THE GLIDING FEDERATION OF AUSTRALIA

GFA AD 554
(ISSUE 1)

GFA AIRWORTHINESS DIRECTIVE

SUBJECT: 1. Checking or replacement of engine suspension frame (all series of engine type Rotax 912A, 912F, 912S or 914F, IF equipped with the genuine Rotax engine suspension frame as notified in Rotax Service Bulletin SB-912-028/SB-914-016).

Bild / Fig. 1

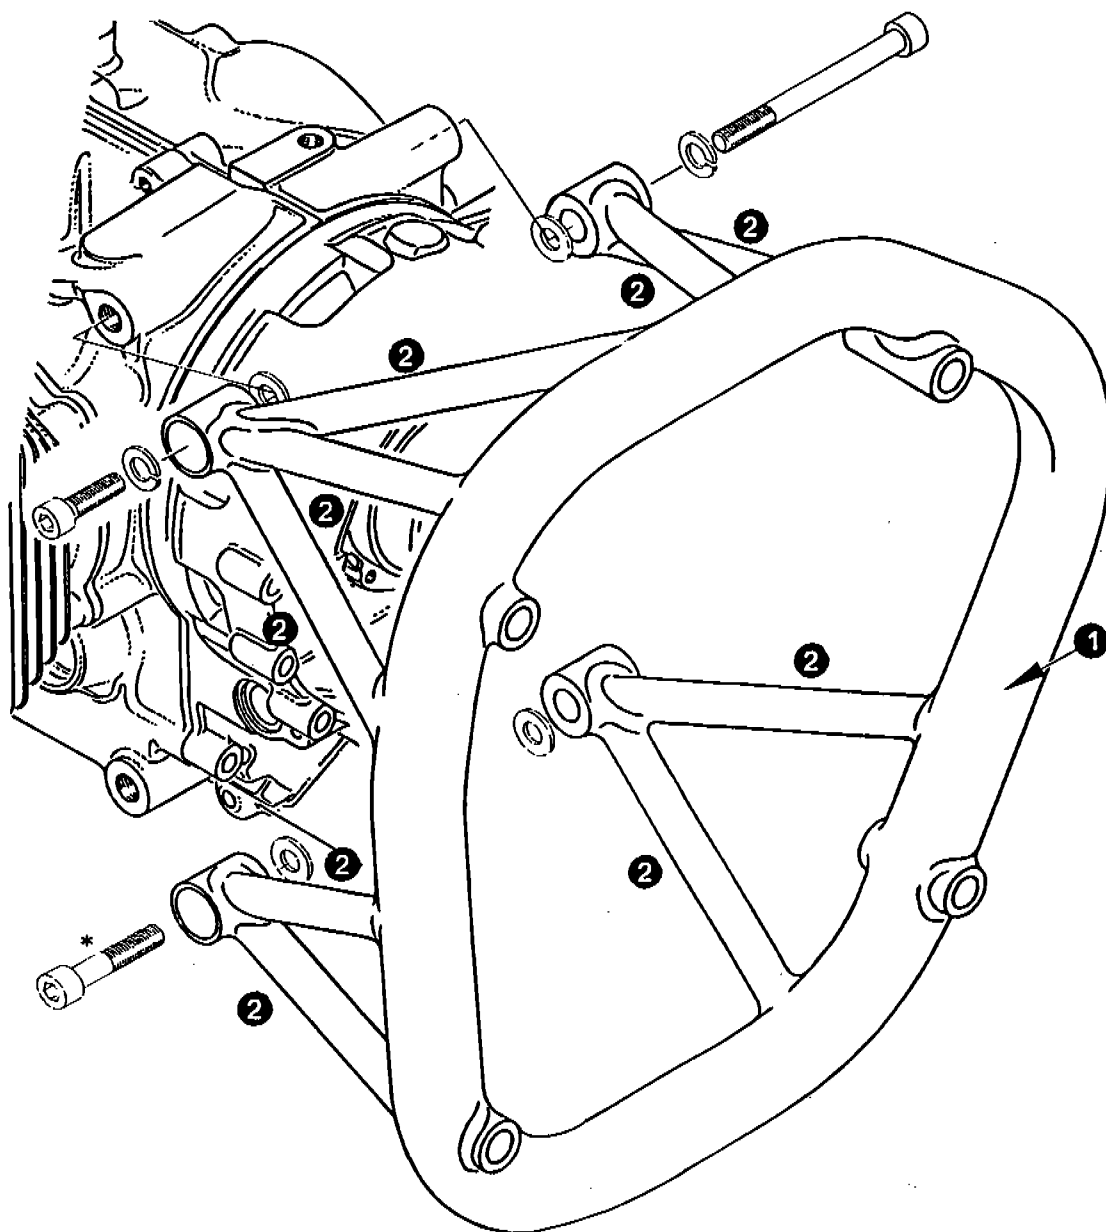
- Inspect the engine suspension frame assy. in accordance with the relevant Maintenance Manual 914 F. That is also effective ROTAX 912 engines.

◆ **NOTE:** Scrutinize the welding connections of circular tubing (1) and the struts (2) of the suspension frame. See fig. 1.

- If cracks are detected replace the engine suspension frame in accordance with the relevant Maintenance Manual 914 F. That is also effective ROTAX 912 engines.

◆ **NOTE:** If absolutely necessary, and if only one of the circular tube or struts are not cracked by more than 50%, a ferry flight is permitted. At complete fracture replacement without delay will be necessary.

Bild / Fig. 1

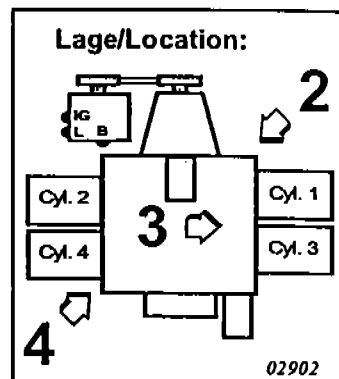
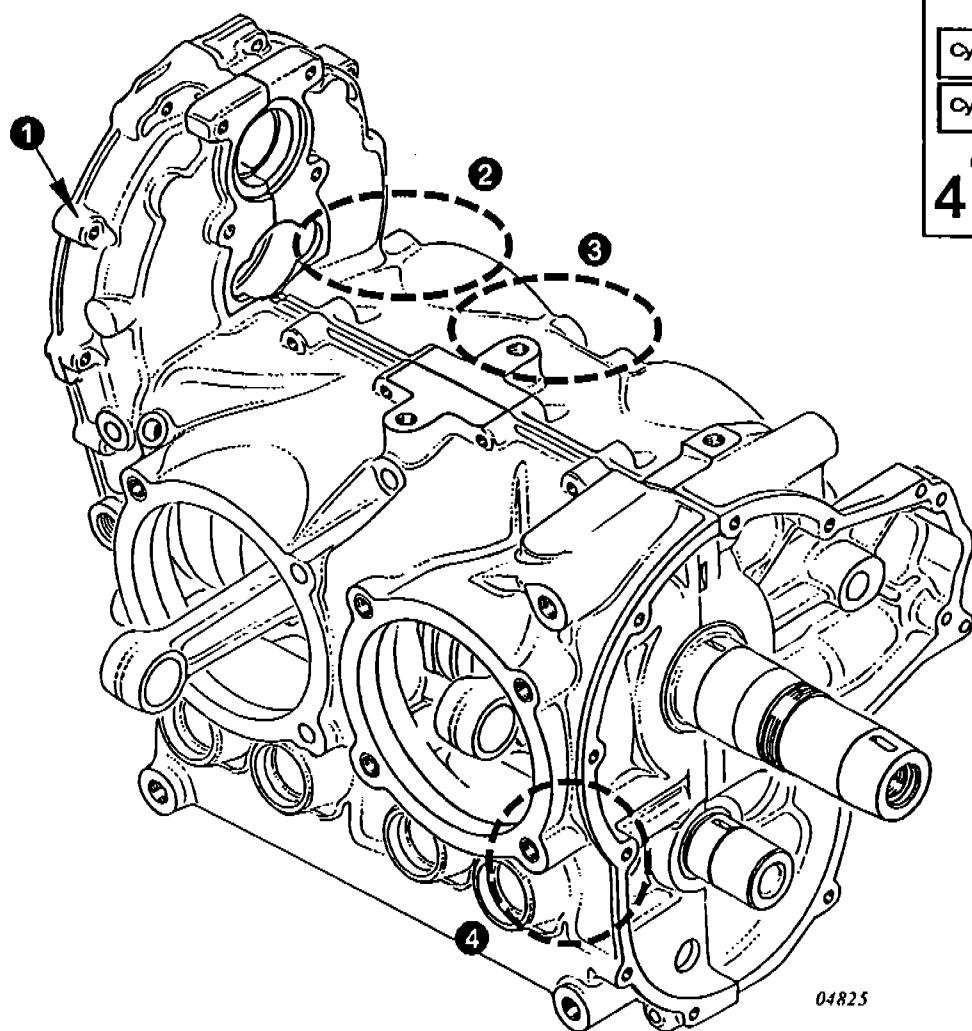
- Inspect the crankcase (1) and engine suspension in accordance with the relevant Maintenance Manual.

◆ **NOTE:** Scrutinize the crankcase for cracks especially in the area of cylinder 1 upper side (2), between cylinder 1 and 3 upper side (3) and cylinder 4 lower side (4). See fig. 1.

For those engines using cooling air baffle inspect for oil leaks in area (2) and (3). If leaks are found, then further investigation to determine the cause of the oil leak is required. If the exact origin of the leak can not be determined i.e. governor, then removal of the cooling air baffle may be required. Alternative methods of inspection may be used, i.e. bore scope, to inspect the areas without removal of the shroud.

◆ **NOTE:** If absolutely necessary, and if only a small amount of oil leakage is found, a ferry flight to a maintenance facility is permitted. At a massive oil leakage replacement of engine without delay will be necessary.

- If cracks are detected the nearest ROTAX[®] Authorized Distributor (see also our official ROTAX-Web-Site: www.rotax-aircraft-engines.com) has to be informed and if necessary the engines has to be removed from aircraft and must be returned to a ROTAX[®] Authorized Distributor.
- Reconnect negative terminal of aircraft battery (after installation of engine).
